CORPS OF ENGINEERS

2-1-50	CORRECTED DWG. NO. — ADDENDUM NO. 2
REVISION	DATE
DESCRIPTION	
CORPS OF ENGINEERS U. S. ARMY OFFICE OF THE DISTRICT ENGINEER HUNTINGTON, W. VA.	
DRAWN BY: E.S.W.	TUSCARAWAS RIVER LOCAL PROTECTION PROJECT MASSILLON, OHIO SIPPO CREEK PUMP STATION LOCATION PLAN & PROFILES
TRACED BY: L.L.L.	
CHECKED BY: M.W.W.	
APPROVED BY: J. E. Johnson	
DATE: DEC. 1949	DATE: DEC. 1949
SCALE: AS SHOWN	SPEC. NO.
DRAWING NUMBER 0271-PM-51.3/1	SHEET 25 OF 42

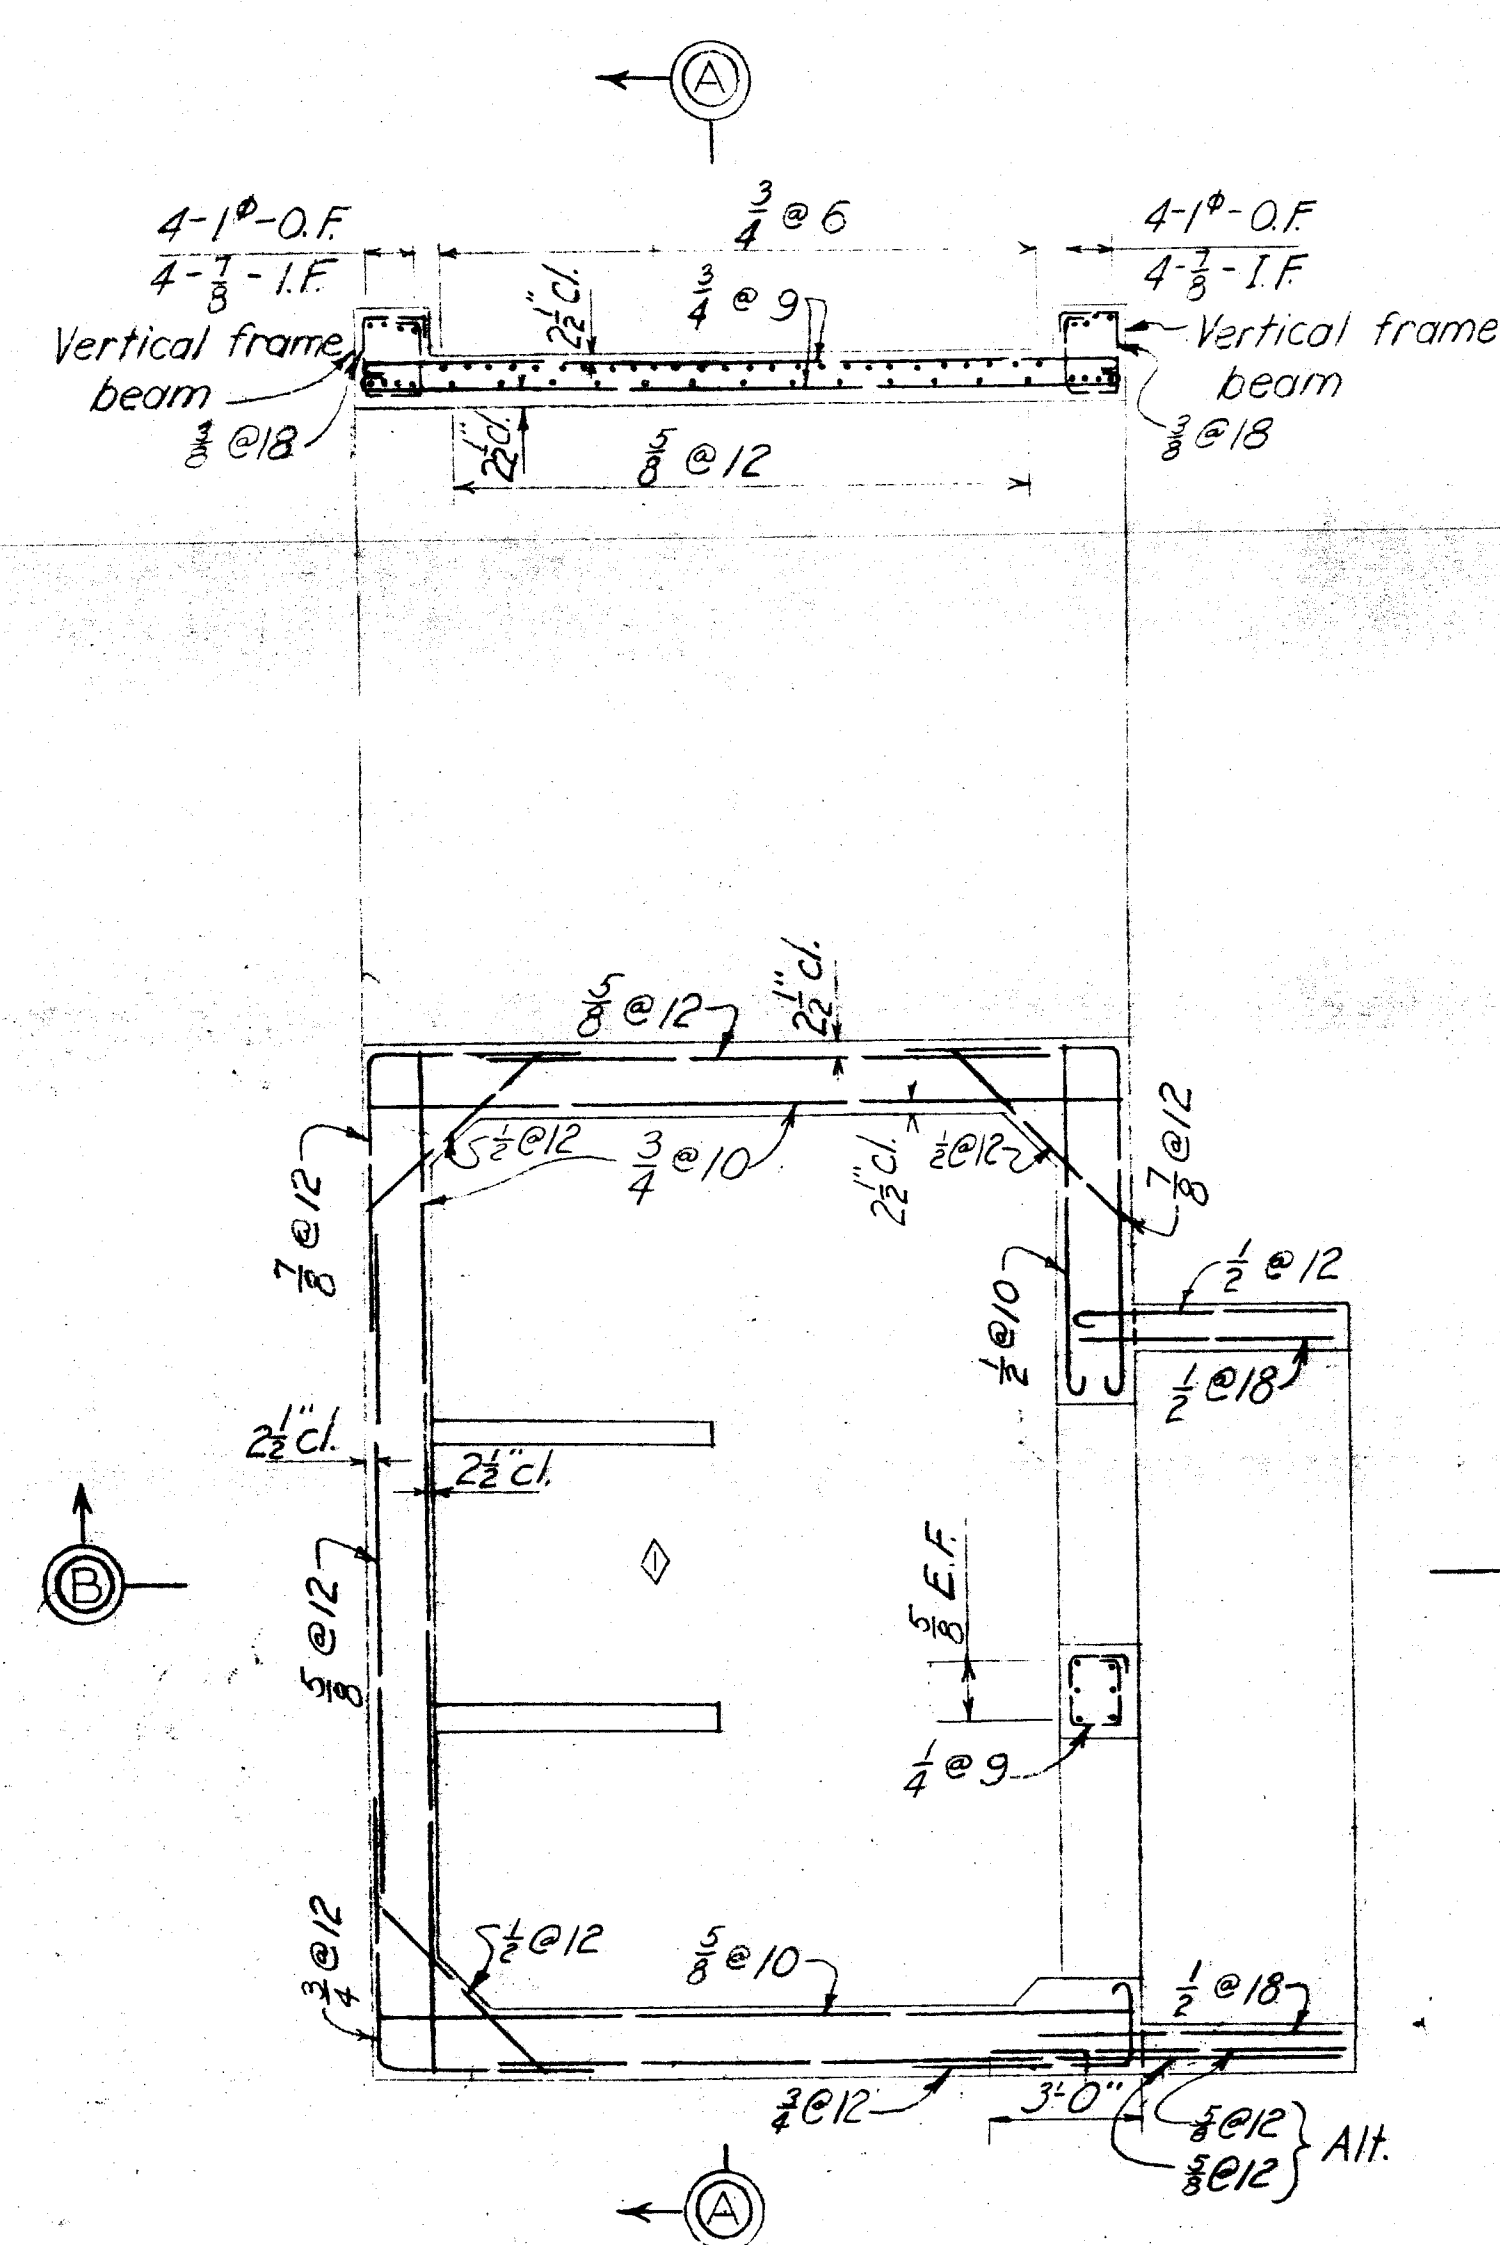
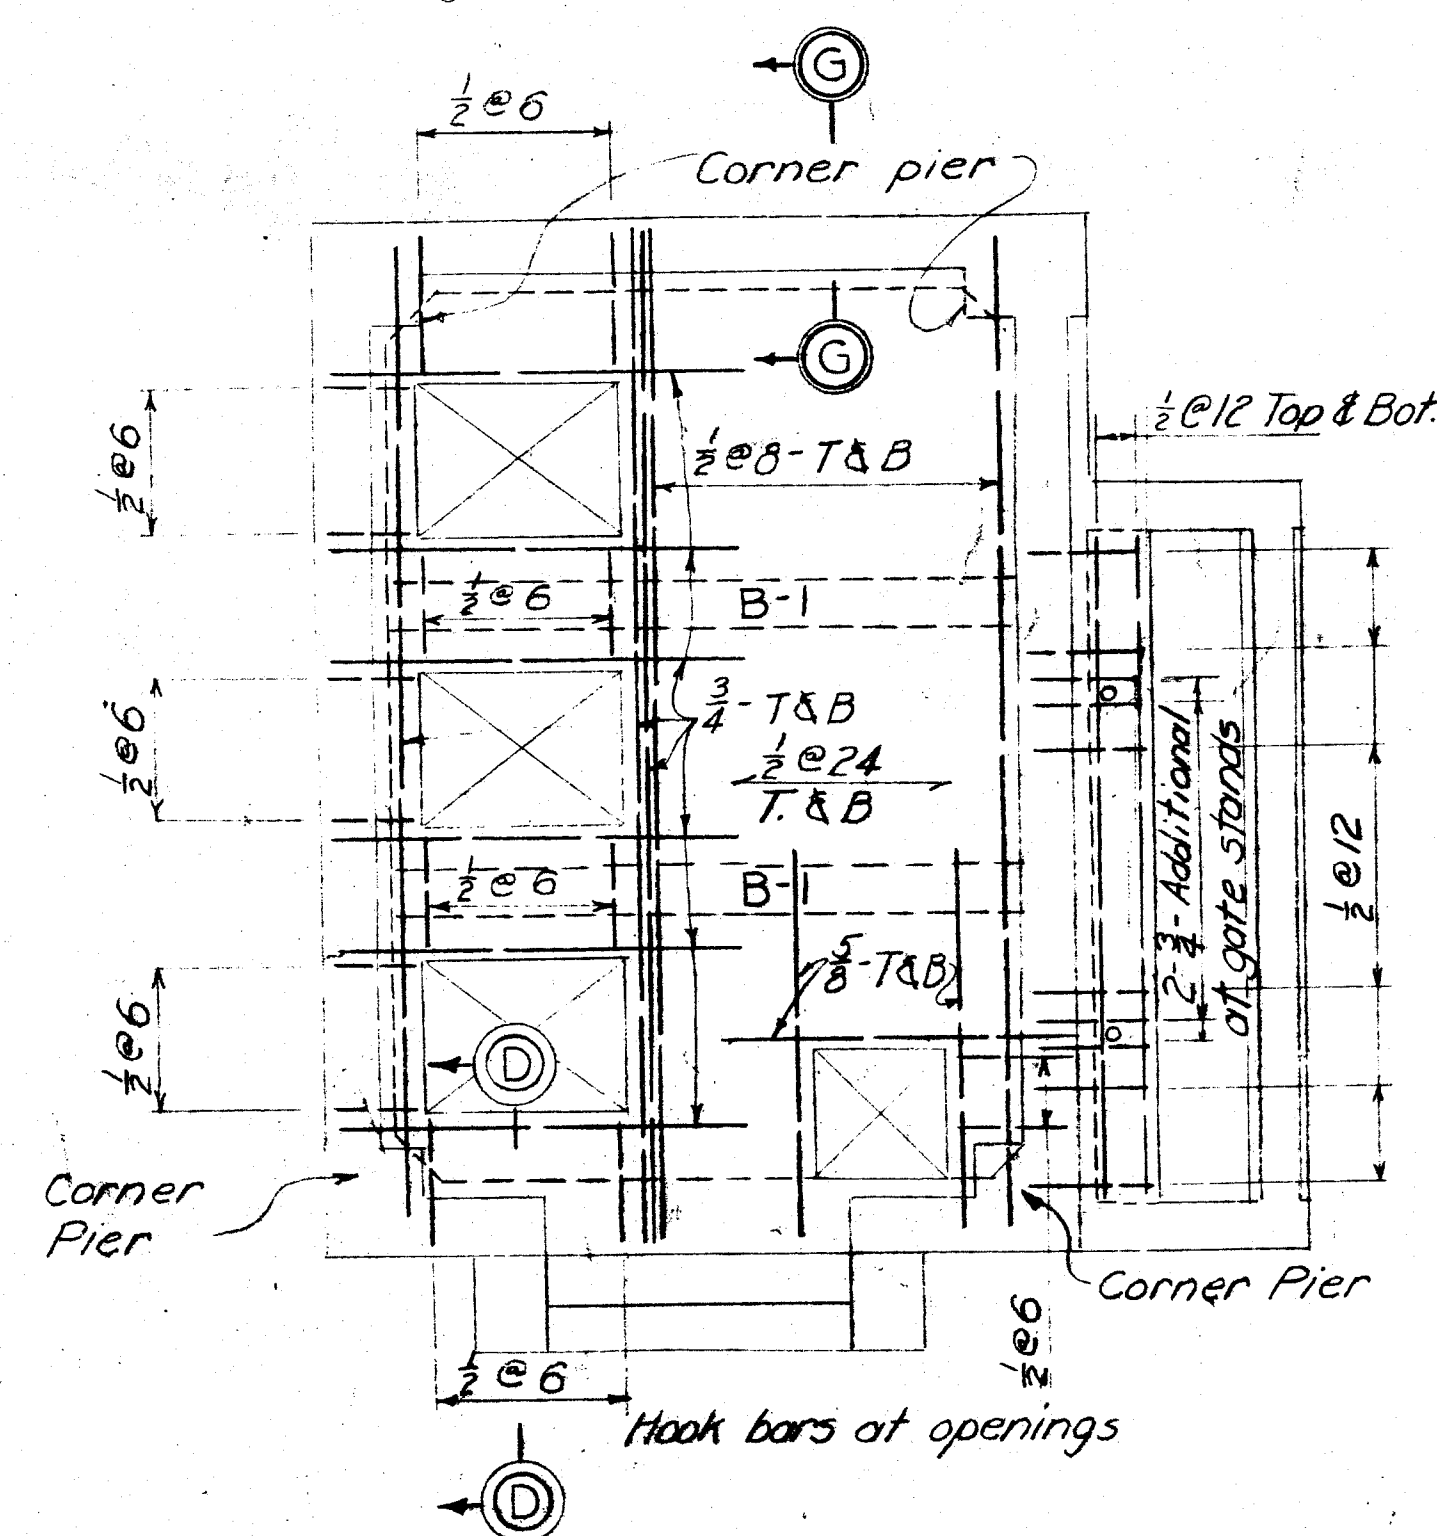
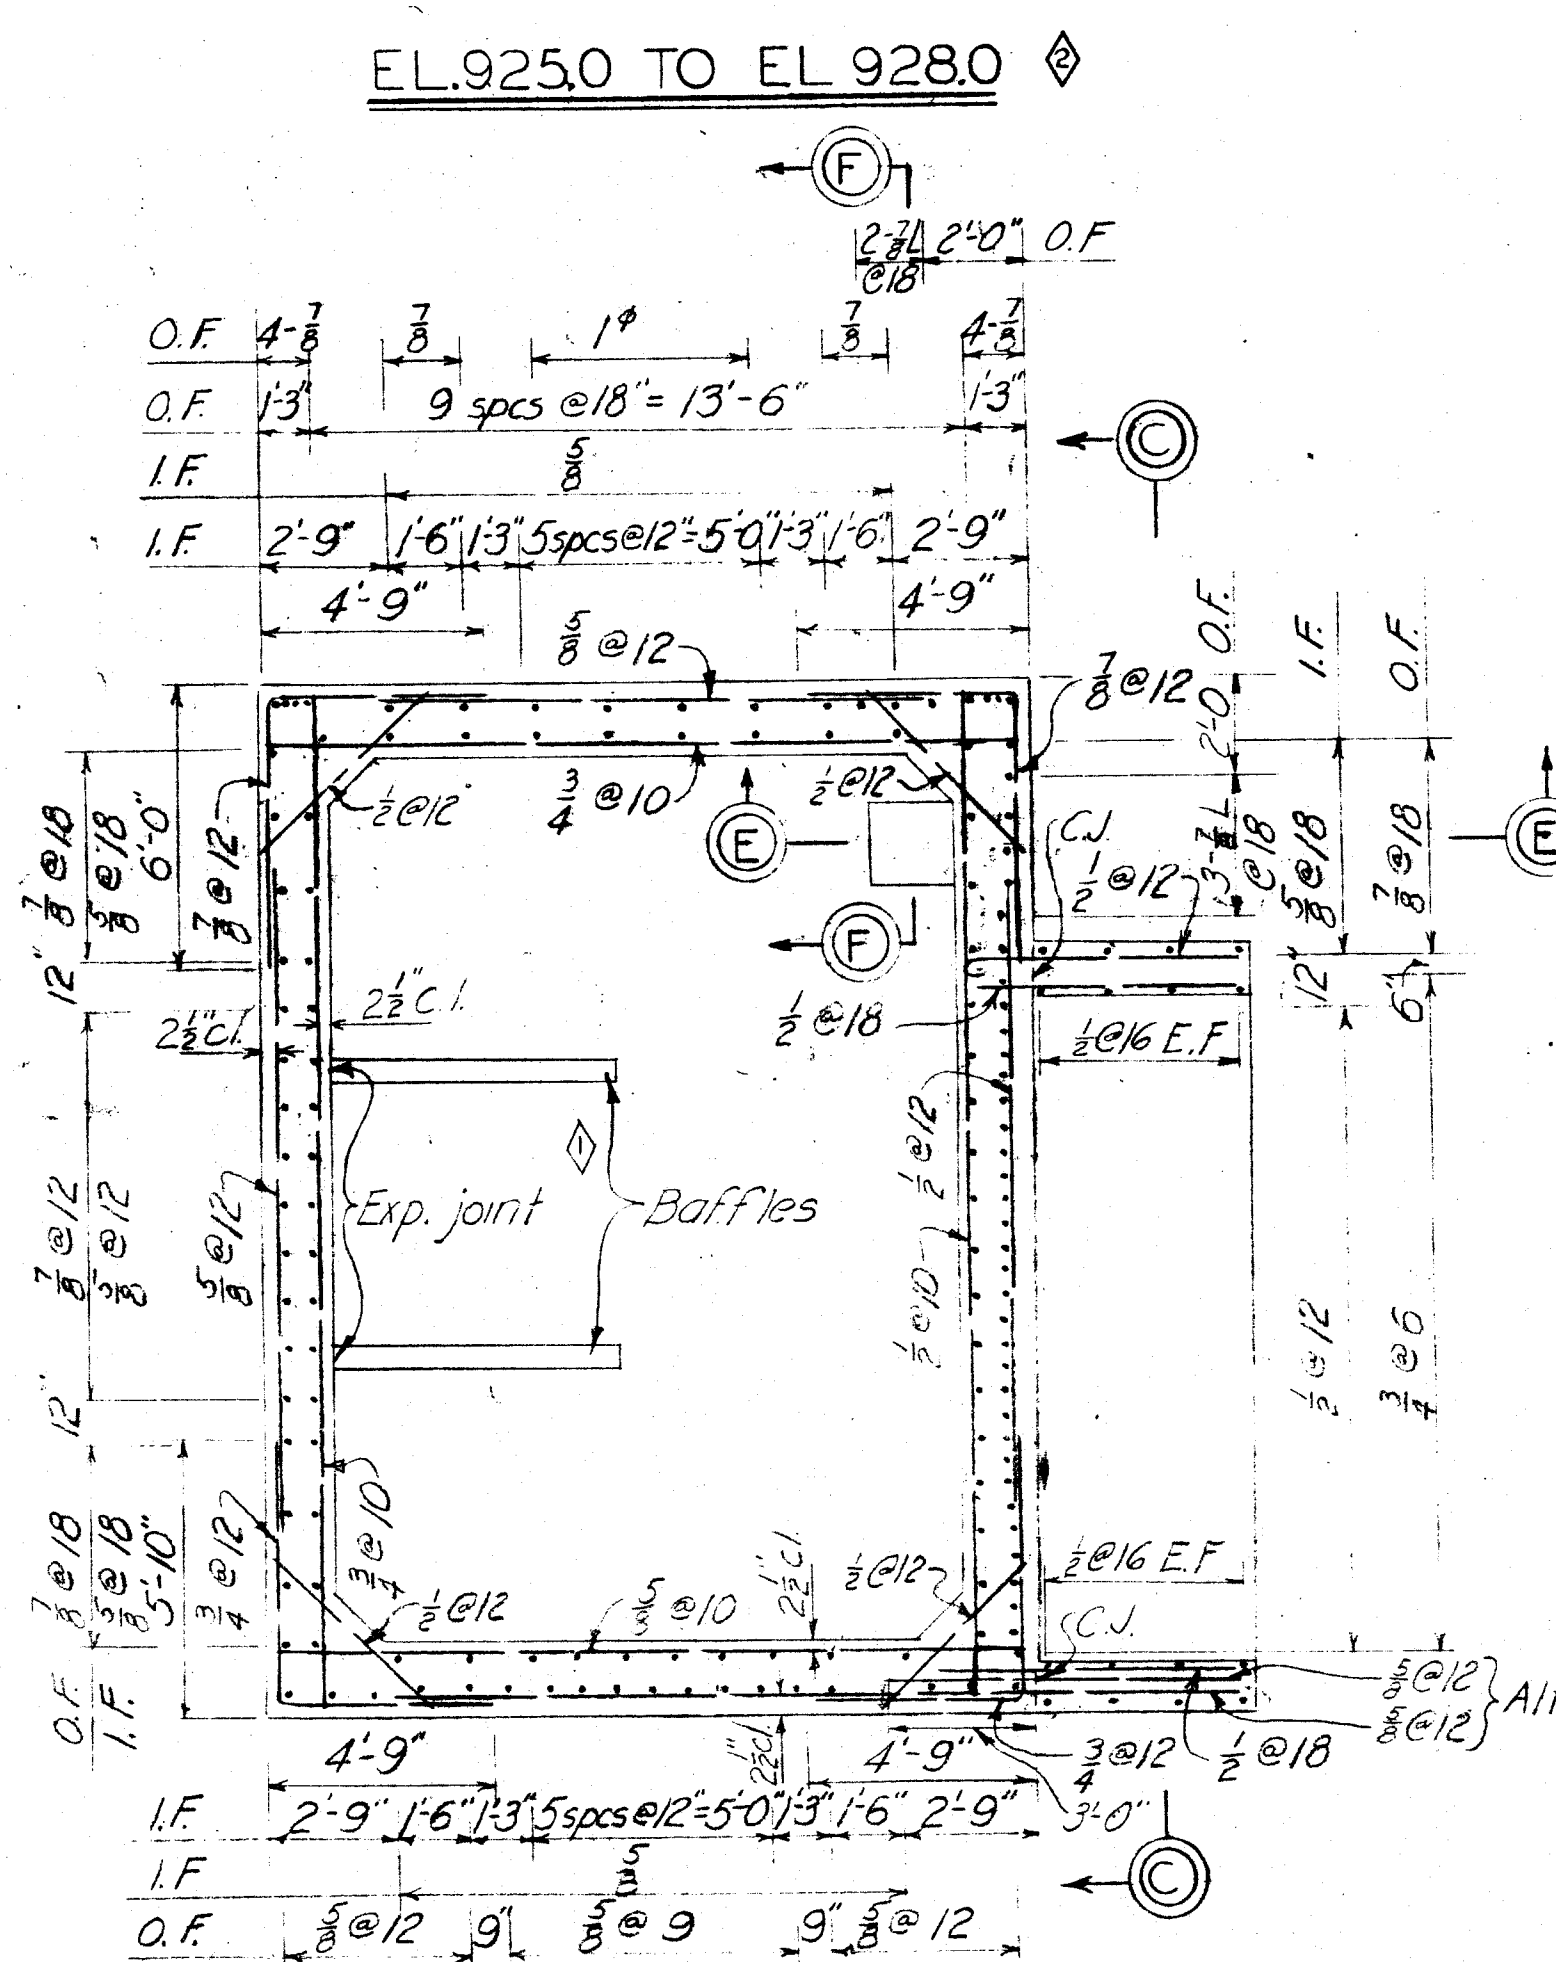
2-1-50	DELETED HOOKS AT HAUNCHED CORNERS-ADDENDUM NO. 2	K.S.B.
1-9-50	ADDED BAFFLES-ADDENDUM NO. 1	K.S.B.
REVISION	DATE	DESCRIPTION
CORPS OF ENGINEERS		
OFFICE OF THE DISTRICT ENGINEER		
HUNTINGTON, W. VA.		
TUSCARAWAS RIVER		
LOCAL PROTECTION PROJECT		
MASSILLON, OHIO		
SIPO CREEK PUMP STATION		
REINFORCING DETAILS		
DRAWN BY:	E.S.W.	
TRACED BY:	F.W.L.	
CHECKED BY:	H.D.G.-M.W.W.	
SUBMITTED BY:	Mr. [Signature]	
APPROVED:	Mr. [Signature]	
CHIEF ENGR. ASST.		
APPROVED FOR:		
DATE:		
DATE:	DEC. 1949	
SCALE:	1/4" = 1'-0"	
DRAWING NUMBER	0271-PM-51.3/4	
SHEET	20 OF 42
